TO: Ryanne Sass, Plaza Street Partners
FROM: Stacey Nerger, Senior Planner
DATE: August 1, 2022
SUBJECT: Lincoln Professional Park – Preliminary Site Plan
Review Comments 04

LINCOLN PROFESSIONAL PARK FILING NO.1 PRELIMINARY SITE PLAN

LINCOLN PROFESSIONAL PARK FILING NO.1 PRELIMINARY SITE PLAN

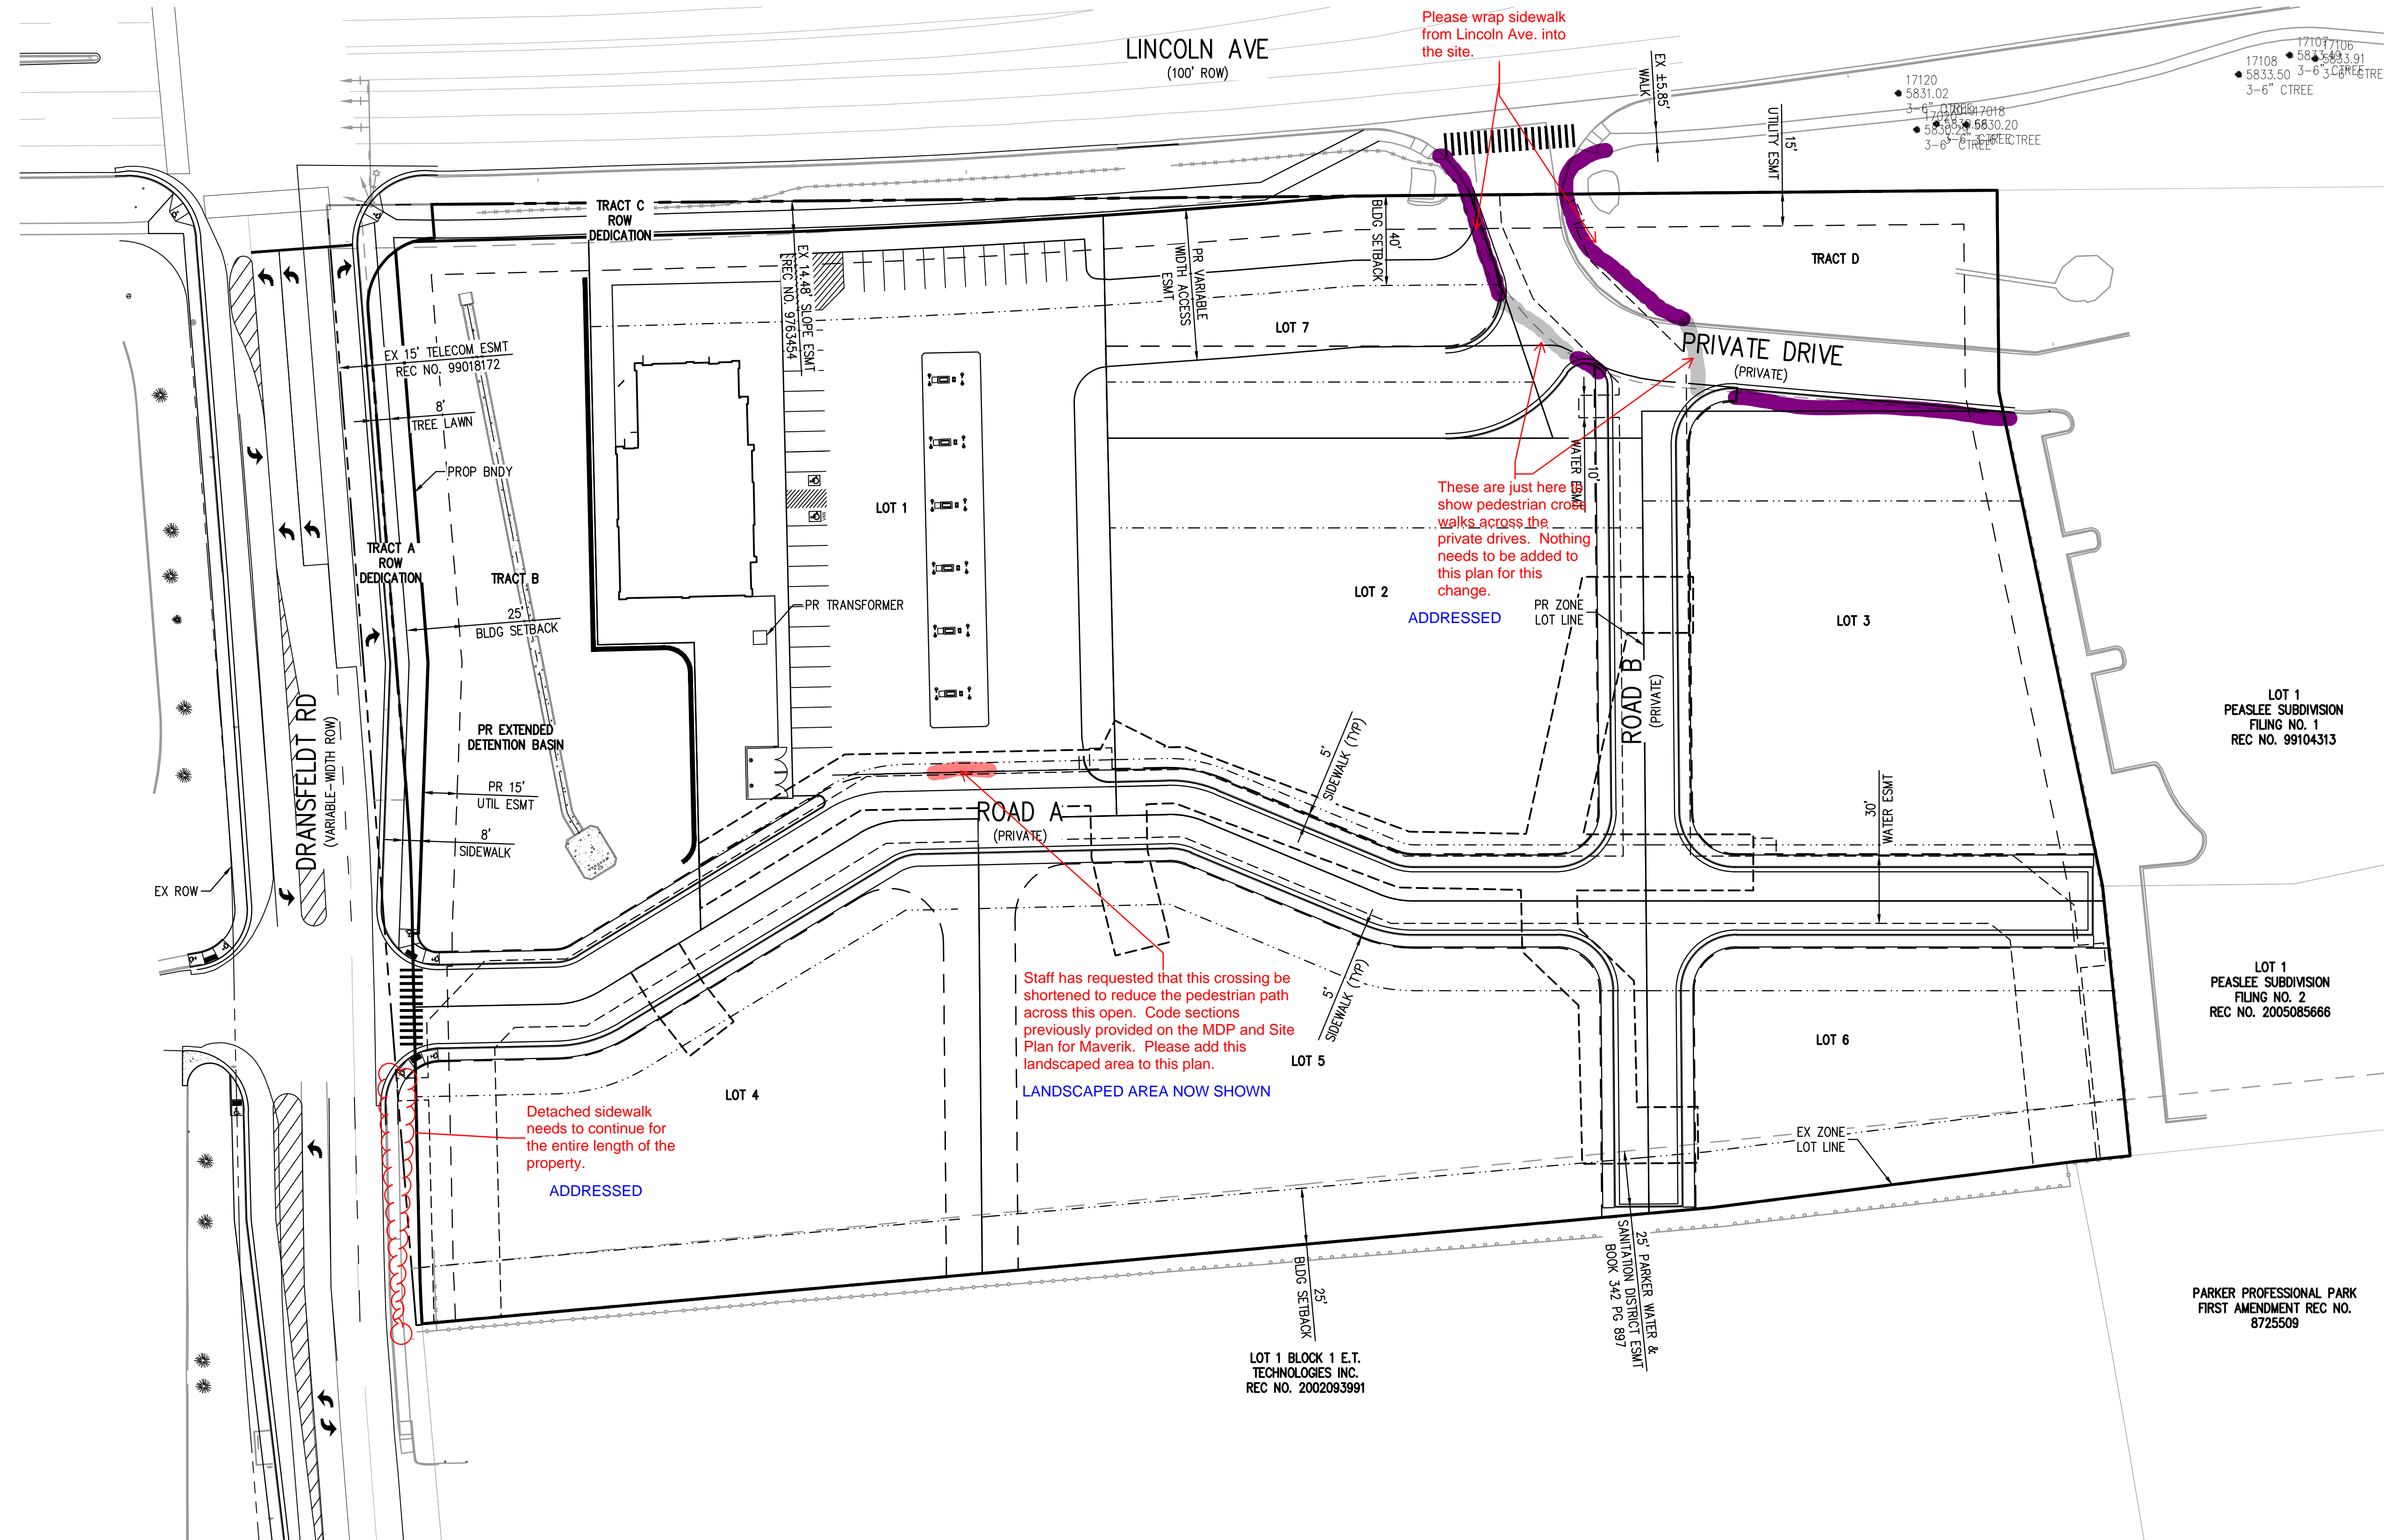
Please wrap sidewalk from Lincoln Ave. into the site.

These are just here to show pedestrian crosswalks across the private drives. Nothing needs to be added to this plan for this change.

Staff has requested that this crossing be shortened to reduce the pedestrian path across this open. Code sections previously provided on the MDP and Site Plan for Maverik. Please add this landscaped area to this plan.

Detached sidewalk needs to continue for the entire length of the property.

LINCOLN PROFESSIONAL PARK FILING NO.1 PRELIMINARY SITE PLAN

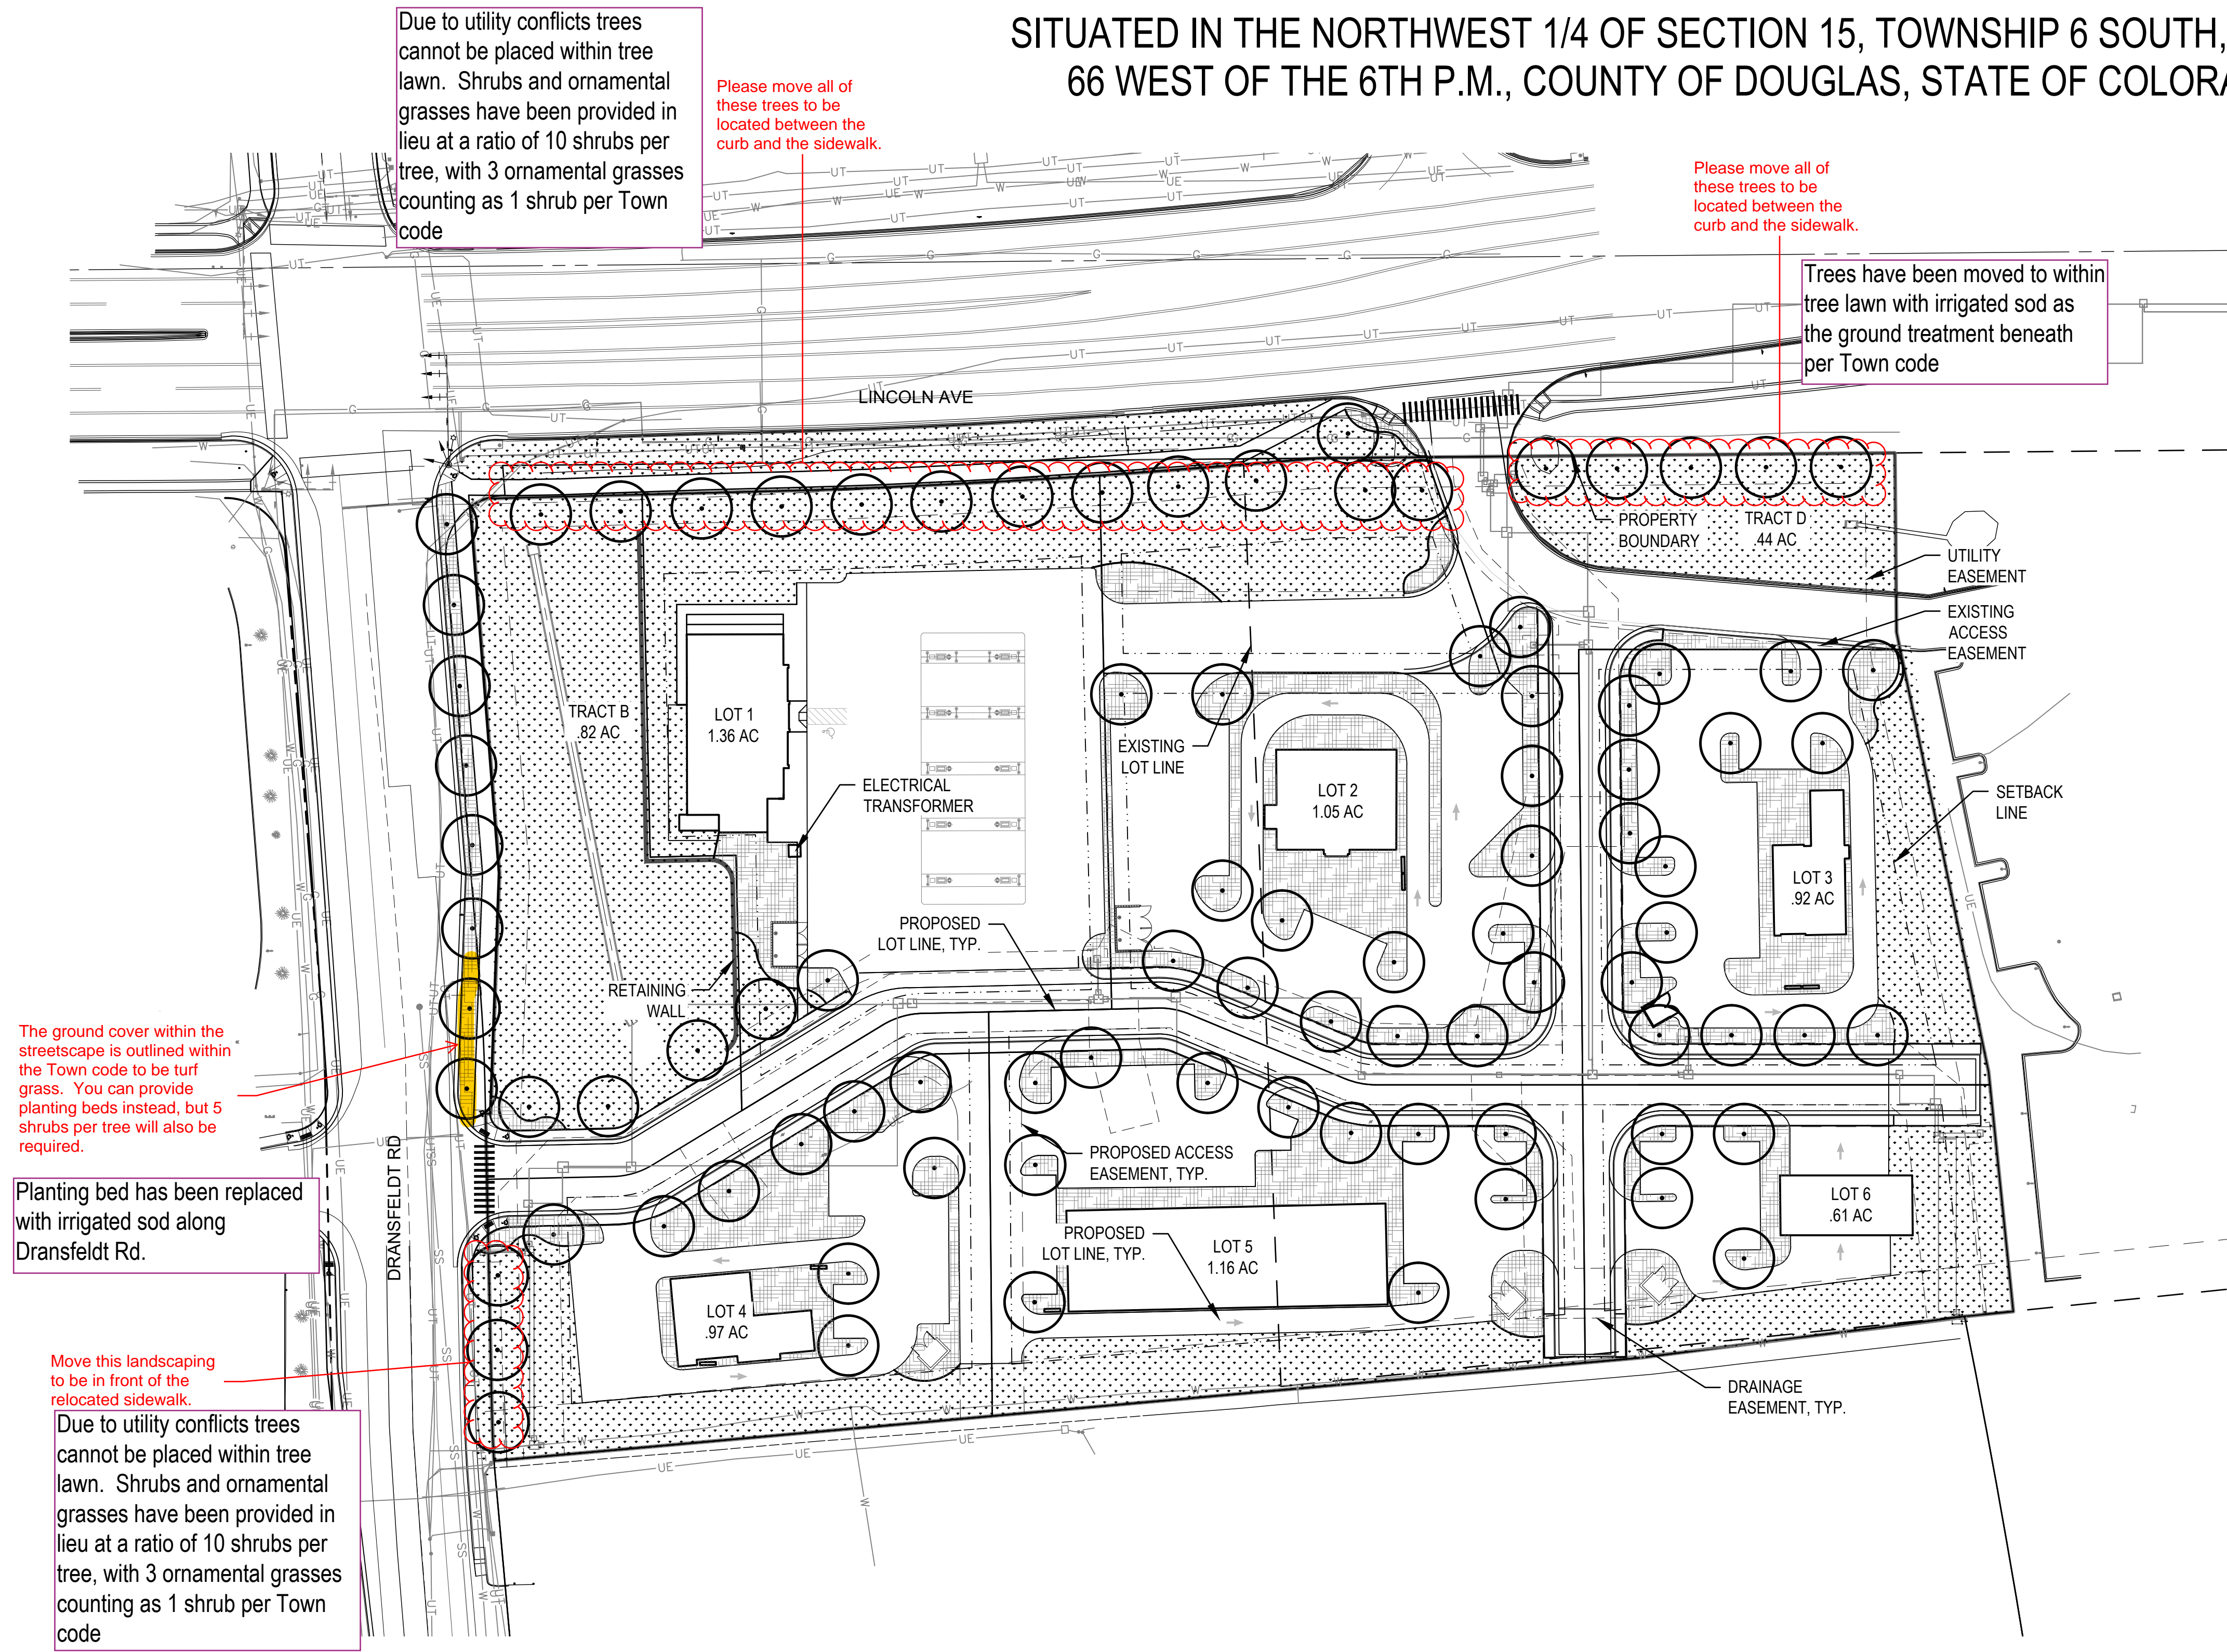
Please move all of these trees to be located between the curb and the sidewalk.

Please move all of these trees to be located between the curb and the sidewalk.

The ground cover within the streetscape is outlined within the Town code to be turf grass. You can provide planting beds instead, but 5 shrubs per tree will also be required.

Move this landscaping to be in front of the relocated sidewalk.

Within these calculations you can subtract the entrance and exits from the total number. For the internal roads, leave these as is since the entrance and exits into each property have not been determined and what is shown will most likely not be allowed due to spacing requirements.

Due to utility conflicts trees cannot be placed within tree lawn. Shrubs and ornamental grasses have been provided in lieu at a ratio of 10 shrubs per tree, with 3 ornamental grasses counting as 1 shrub per Town code

Trees have been moved to within tree lawn with irrigated sod as the ground treatment beneath per Town code

Planting bed has been replaced with irrigated sod along Dransfeldt Rd.

Due to utility conflicts trees cannot be placed within tree lawn. Shrubs and ornamental grasses have been provided in lieu at a ratio of 10 shrubs per tree, with 3 ornamental grasses counting as 1 shrub per Town code

Entries and exits have been subtracted from calculations for Lincoln and Dransfeldt. For internal streets, radii at intersections have been omitted from calculations but potential access for lots has remained included.
